**RE: Clause 23 further information request – Private Plan Change Request by Windsor Park Community and Multisport Hub Incorporated**

Further to your private plan change request under clause 21 of Schedule 1 of the Resource Management Act 1991 (RMA) in relation to the rezoning of 20 Noel Williams Place (Windsor Park), the Council has now completed an assessment of the information supplied.

# APPENDIX 1: FURTHER INFORMATION REQUESTED UNDER CLAUSE 23 FIRST SCHEDULE OF THE RESOURCE MANAGEMENT ACT 1991

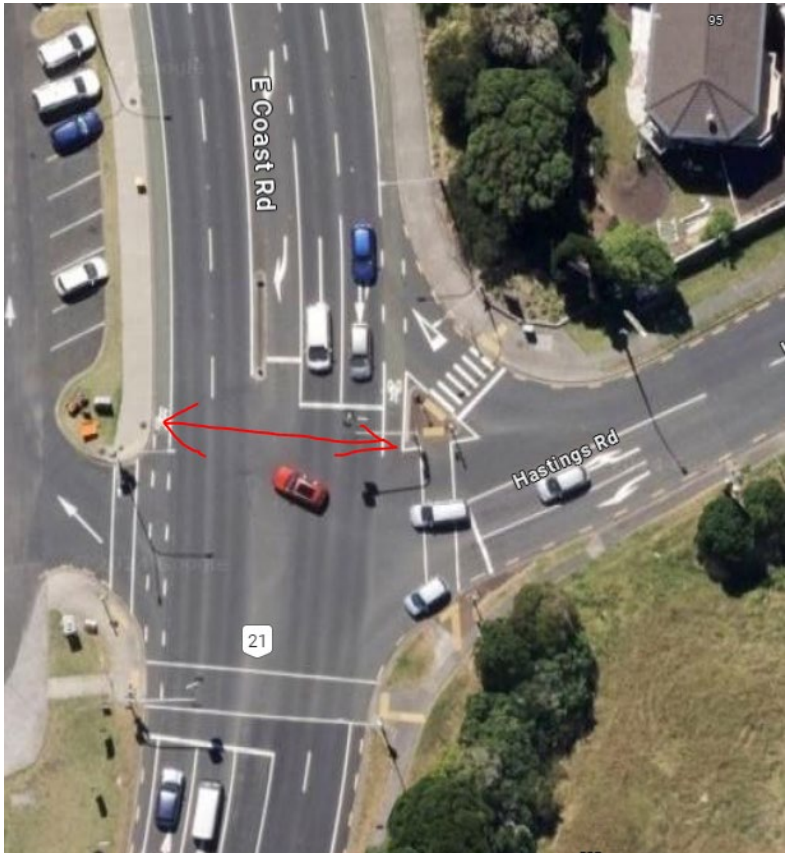
T3	Trip Distribution	<p>Please justify the trip distribution used for the assignment of development trips at the Noel Williams Place / East Coast Road intersection, taking into account the information available from Statistics NZ from 'commuter waka'.</p> <p>If a different trip distribution is derived, the assessment, including traffic modelling, should be updated accordingly.</p>	<p>Section 4.6.3 of the ITA presents figures of the assignment of development trips to the Noel Williams Place intersection. The distribution favours traffic turning to and from the north (which appears to be based on the existing movements at the intersection). The 'Commuter waka' data presented in Figure 10 of the ITA indicates that there are many work/school departures south of the subject site.</p> <p>As Noel Williams Place is not solely used by residents, it may not be sufficient to rely on the existing turning movements to/from East Coast</p>

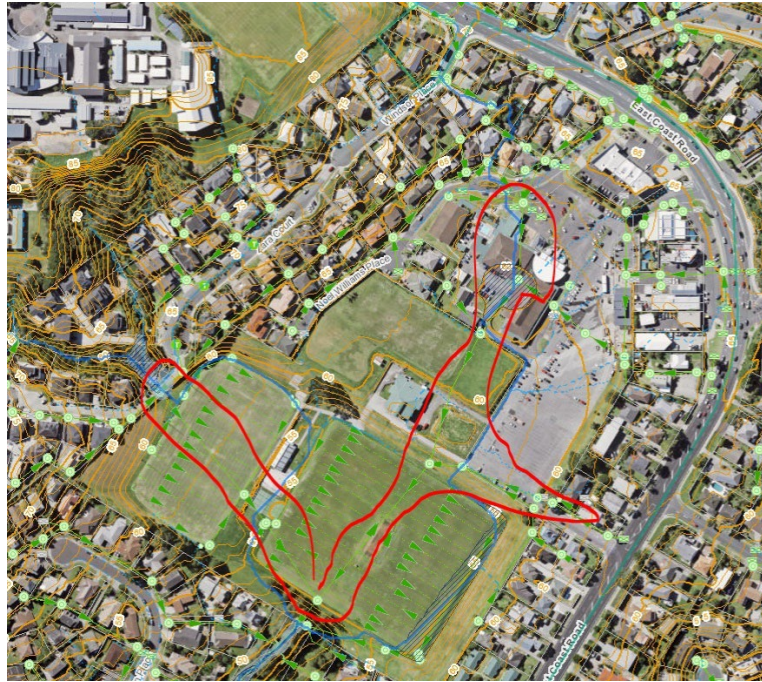
<p>The applicant is advised that the developer is responsible for monitoring the road's condition during the construction period and repairing any damage that occurs as a result. This should be addressed in the Construction Traffic Management Plan at later consenting stages.</p> 	
9	Certainty of mitigation	<p>The ITA recommends mitigation i.e. additional NSAAT markings, some footpath widening, and a footpath connection to the Windsor Park carpark access.</p> <p>The applicant is advised that this mitigation is not guaranteed as part of the plan change which rezones the land for development. Whether or not Council is able to require the mitigation as part of later land use and/or subdivision consent processes is dependent on the scale of development and how consenting is approached by the applicant.</p>

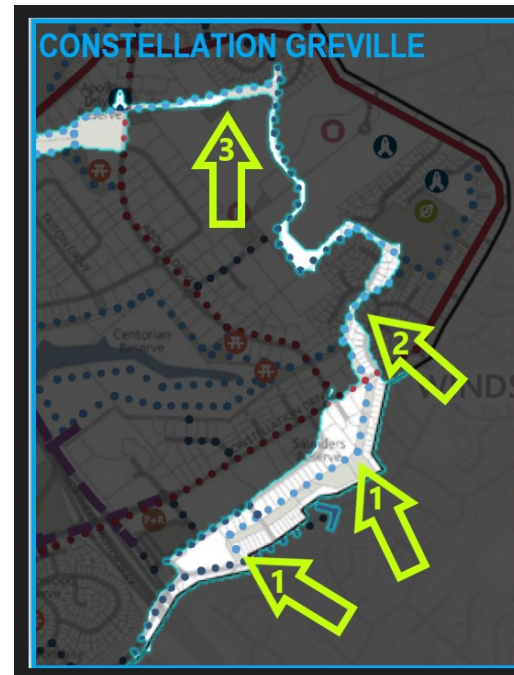
- An attached plan (see below) lifted from the Greenways Plan highlights a loop connecting the new Rosedale Busway Station and the existing Constellation Station through Centurian Reserve to Windsor Park, Millennium Stadium and Rangitoto College. The proposal shows a non-vehicular connection to the Southwest which would be ideal. Any future connection that would link to the walkway at 59 Zara Court would also be a great addition to the network.
